Amendments to the Drawings:

Annotated Sheet Showing Changes to Fig. 6

Atty. Docket No. 3183-002-01
KILYK & BOWERSOX, P.L.L.C.
400 Holiday Court, Suite 102
Warrenton, VA 20186
Tel.: (540) 428-1701
Fax: (540) 428-1720

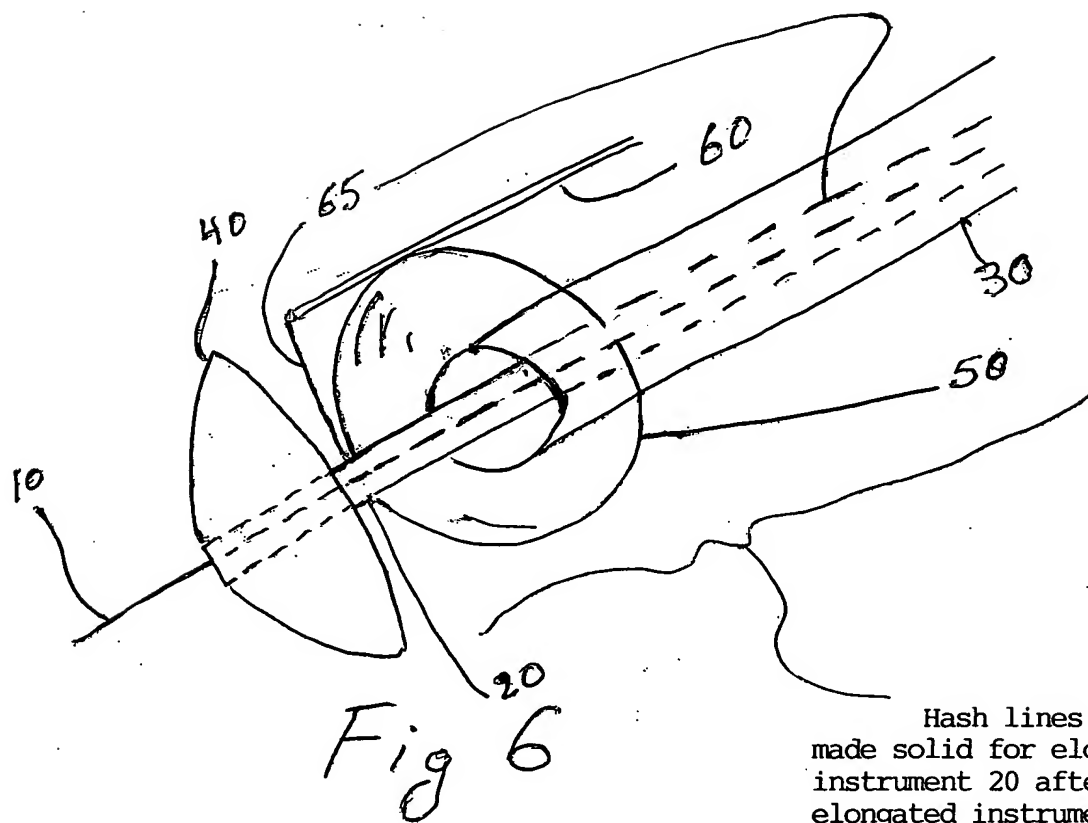
The attached drawing sheet replaces Fig. 6. The replacement sheet of Figure 6 shows that the collapsible plate is located on elongated instrument 20. To make this clear, the hash lines have been re-drawn, and elongated instrument 20 has been drawn to show that it is extending beyond the elongated instrument 30.

At page 2 of the Office Action, the Examiner objects to Figure 6 and asserts that the collapsible plate (40) appears to be located on the guide, rather than on either of the elongated instruments as disclosed. This objection is respectfully traversed.

Hash lines have been made solid for elongated instrument 20 after exiting elongated instrument 30 and hash lines corresponding to elongated instrument 20 and guide 10 have been corrected

New Figure 6 was intended to show that the collapsible plate is located on elongated instrument 20. To make this more clearer, the hash lines have been re-drawn, and elongated instrument 20 has been drawn to show that it is extending beyond the elongated instrument 30. Accordingly, this objection should be withdrawn.
